12. COA-084161-2020

724 North 27th Street

Commission of
Architectural Review

STAFF REPORT

Figure 4. 724 N. 27th Street, rear elevation.

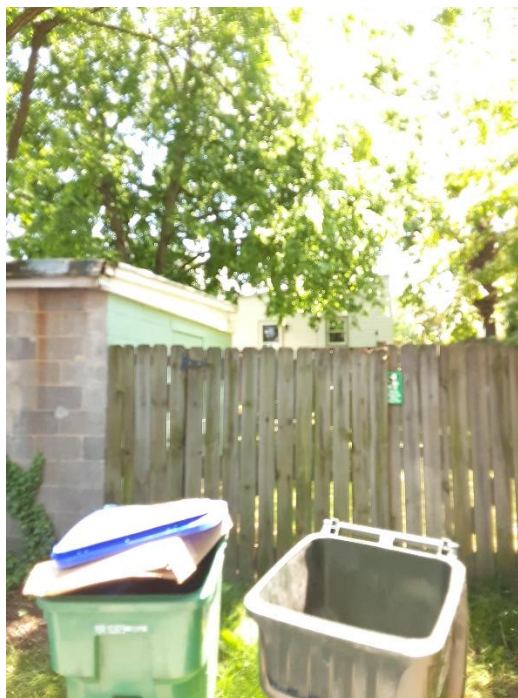
- the walls of the second story addition be inset by at least six inches in order to differentiate from the historic building
- the roof cornice lines not extend past the walls of the historic building in order to maintain the overall form of the historic building
- the roof specifications be submitted for administrative approval
- the applicant lower the sills of the existing windows on the rear mass so that width and height remain unchanged
- the railing be wood and utilize a Richmond Rail, or the pickets be placed on the interior of the rail for a more finished appearance
